UNITED STATES PATENT AND TRADEMARK OFFICE

APPLICATION NO.	FILING DATE	FIRST NAMED INVENTOR	ATTORNEY DOCKET NO.	CONFIRMATION NO.
10/826,046	04/16/2004	Steven S. Homer	200315743-I	9457
22879	7590	03/09/2005	EXAMINER PAPE, ZACHARY	
HEWLETT PACKARD COMPANY P O BOX 272400, 3404 E. HARMONY ROAD INTELLECTUAL PROPERTY ADMINISTRATION FORT COLLINS, CO 80527-2400			ART UNIT 2835	PAPER NUMBER

DETAILED ACTION

Fig 1

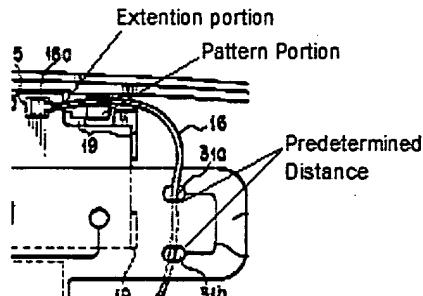
5. With respect to claim 2, Nakajima et al. further teaches that the antenna comprises a conductive trace (12) deposited on an interior surface of the screen member.
6. With respect to claim 3, Nakajima et al. further teaches a display device (7) disposed adjacent an interior surface of the screen member (8).
7. With respect to claim 4, Nakajima et al. further teaches that the antenna extends a predetermined distance along an interior surface of the screen member (As illustrated in Fig 4 between holes 31a and 31b).
8. With respect to claim 5, Nakajima et al. further teaches that the antenna comprises a pattern portion (See Fig 1 below)

9. With respect to claim 6, Nakajima et al. further teaches that the antenna comprises an extension portion extending from the pattern portion to a screen member connector (15, See Fig 1 above).
10. With respect to claim 7, Nakajima et al. further teaches that the antenna comprises an extension portion (16) extending to at least two side areas of the screen member.

19. With respect to claim 18, Nakajima et al. further teaches providing a screen member (10) having a pattern antenna portion (See Fig 1 above) disposed on the interior surface thereof.

20. With respect to claim 19, Nakajima et al. further teaches providing a screen member (10) having an extension antenna portion (As illustrated in Fig 1 above) extending from the pattern antenna portion (Illustrated in Fig 1 above) to a screen member connector (16a).

23. With respect to claim 23, Nakajima et al. further teaches that the antenna comprises a pattern portion (See Fig 1 above)

24. With respect to claim 24, Nakajima et al. further teaches that the antenna comprises an extended portion extending from the pattern portion to a screen member connector (15, See Fig 1 above).

Fig 2

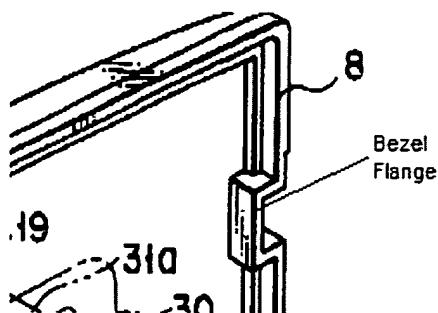
27. With respect to claim 27, Nakajima et al. further teaches the use of a bezel (8, 9) having a flange (See Fig 2 below) disposed between the screen member and the display device.
